Proposed changes to the EEC UN Regulations 29

11 September 2008
Paris

Test A **New proposal** (as proposed by the Russian Federation)

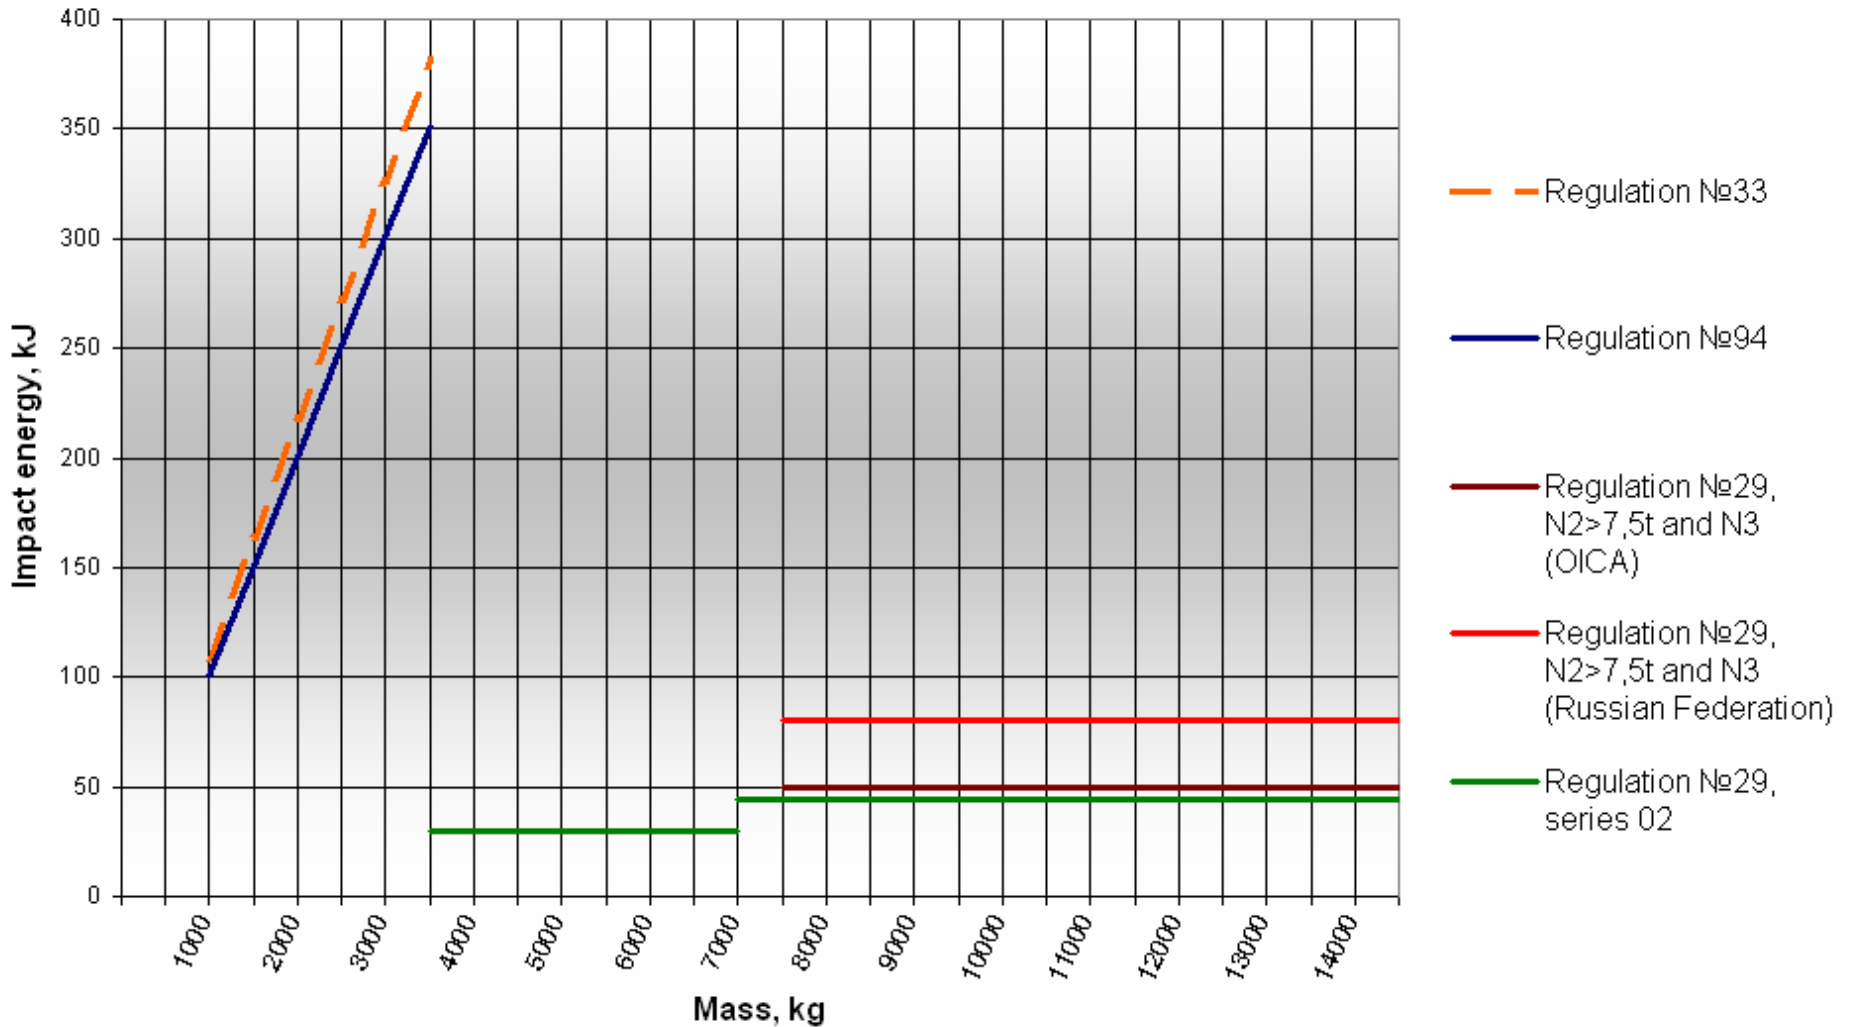
Pendulum energy:

$N1$ and $N2 \leq 7,5t$ – Regulation № 29 series 02

$N2 > 7,5t$ and $N3$ – 78,4 kJ Impact energy;

At least for $N1$ vehicles, allow UNECE R33 or UNECE R94 as alternative

- dimensions: $h=800$ mm; $l=2500$ mm

weight $m = 2500 - 3000$ kg

$c=50\pm 5$ mm (50 ± 5 mm below point $H(R)$)

Test B **New proposal** (as proposed by the Russian Federation)

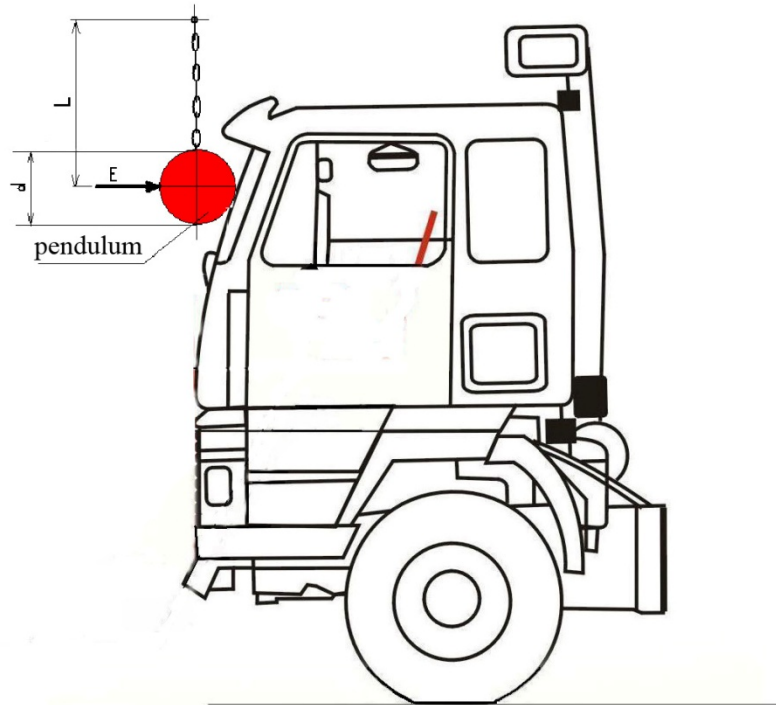
Pendulum energy:

N1 and N2 $\leq 7,5t$ – Regulation № 29 series 02

N2 $> 7,5t$ and N3 – 29,4 kJ Impact energy;

- dimensions: $d=600$ mm; $l=2500$ mm
weight $m \geq 1000$ kg

The pendulum shall strike at the point located at the middle of the cabin glass in the vertical plane.

Test C **New proposal** (as proposed by the Russian Federation)

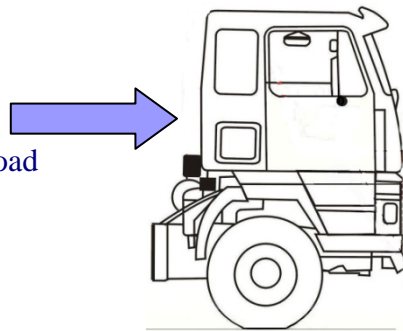
$N1$ and $N2 \leq 7,5t$ – Regulation № 29 series 02

**$N2 > 7,5t$ and $N3$ $P = K \times PCH \leq 10\tau$,
where PCH – full load of the vehicle that falls to the front
axle;**

$K = 2,5$ – dynamic load coefficient.

Test D **New proposal**

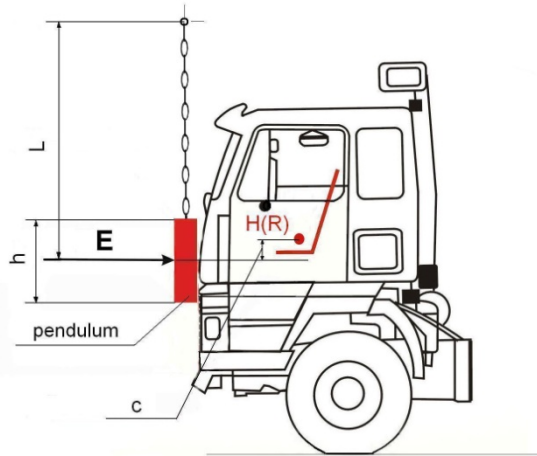
N1 and N2 \leq 7,5t – Regulation № 29 series 02

Pendulum energy:

N2 > 7,5t and N3 – 29,4 kJ

dimensions: h=500 mm; l=1600 mm

weight m = 1000kg
